## COMMENT FORM

**California American Water Company (Cal Am)  
Monterey Peninsula Water Supply Project  
Draft Environmental Impact Report**

**DRAFT**  
**Figure 64**

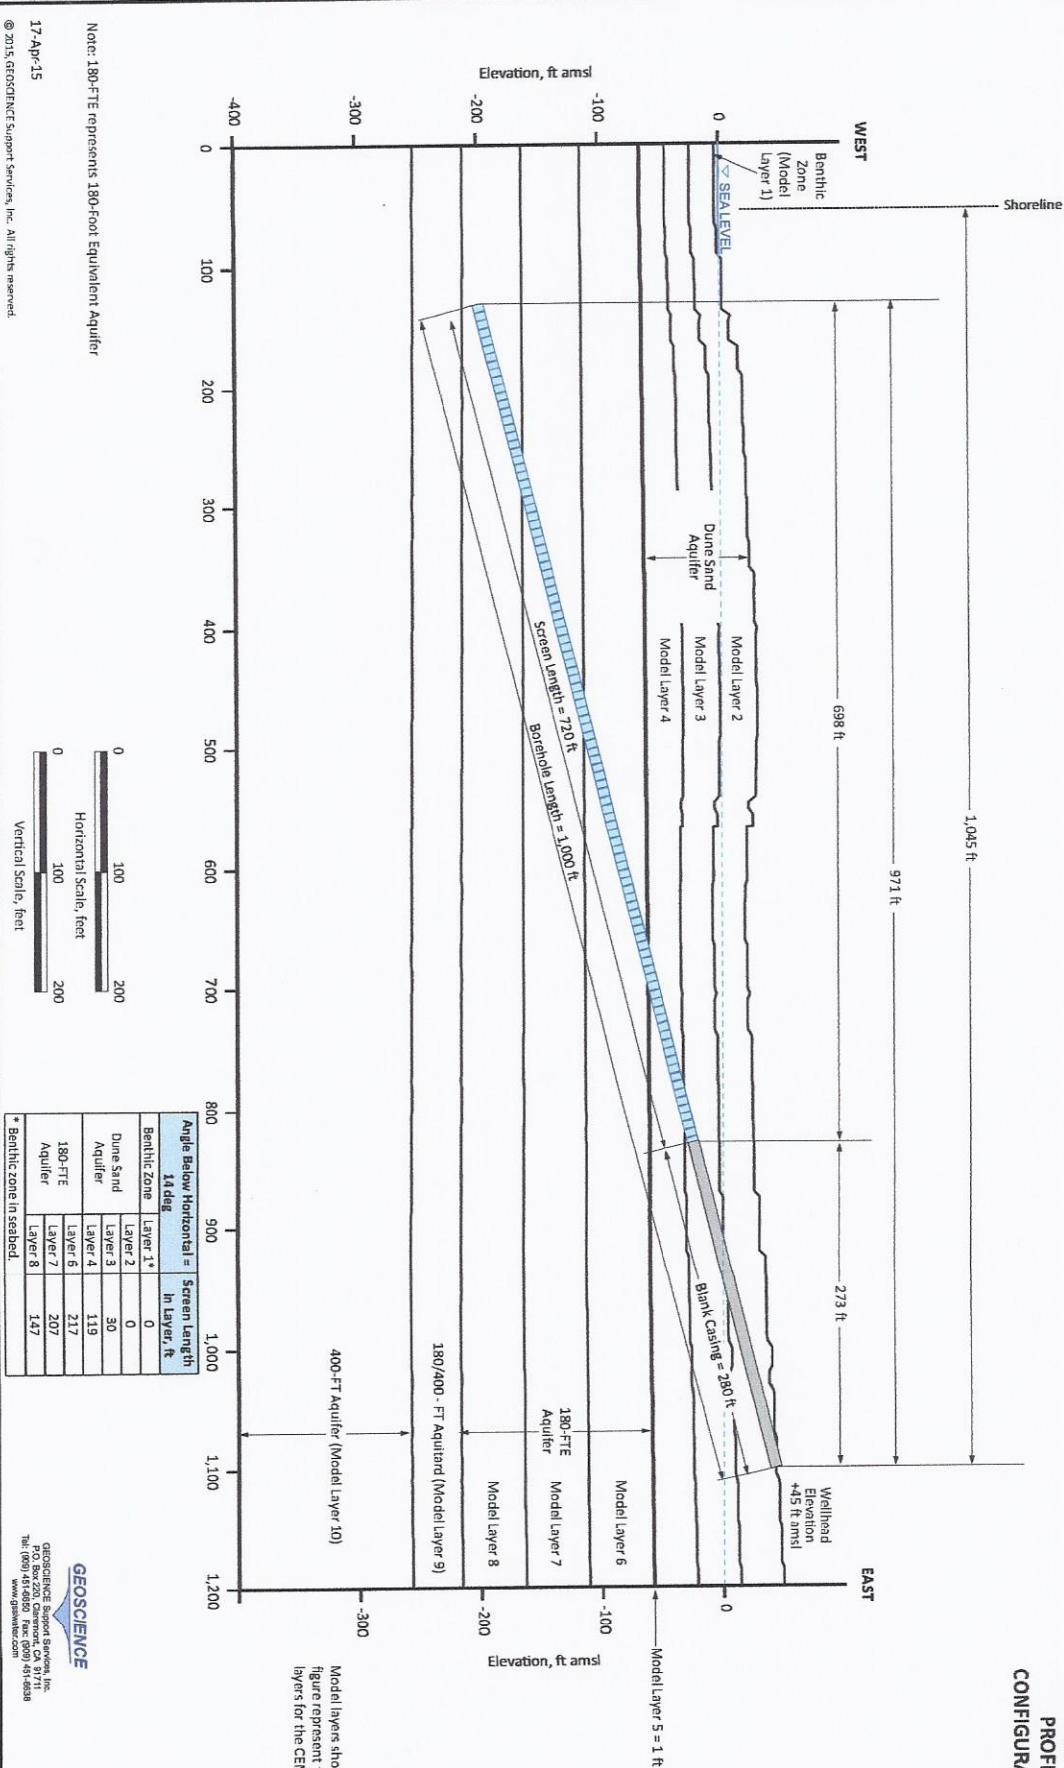
Not only is this disingenuous; it is also deceitful. The very objective of the proposed slant wells, shown clearly in Figure 64, is not to avoid pumping from Salinas Valley aquifers, as originally announced, but in fact to pump directly from them, without acknowledging that objective publicly. In fact, Cal Am is using an inadequately and likely erroneously evaluated model to predict insignificantly low fresh-water percentages in the feed water, percentages that can be returned to the valley groundwater basin without affecting the project's capability to meet its delivery requirements on the Monterey Peninsula. This fresh-water

These claims have two problems. One is that the reason growers are not using the groundwater is to avert the very seawater intrusion that Cal Am's pumping is exacerbating. The second is that Cal Am is directly accessing groundwater, whatever its salinity, and exporting it out of the valley, partly to the Monterey Peninsula (fresh-water component) and partly to Monterey Bay (residual component). This is an obvious violation of the Agency Act.

**REMEDICATION.** Since a slant well cannot extend far enough out into the bay to avoid accessing the Salinas Valley groundwater basin, Cal Am should either pursue open-ocean intake or seek a site outside the Salinas Valley to obtain its feed water. One possibility is to use slant wells extending beneath the sea floor near the mouth of the Carmel River, where neither water rights nor the Agency Act would present a problem. The EIR should explore this possibility, as well as open-ocean intake.

If you do not take these remediation measures, please explain, Why not?
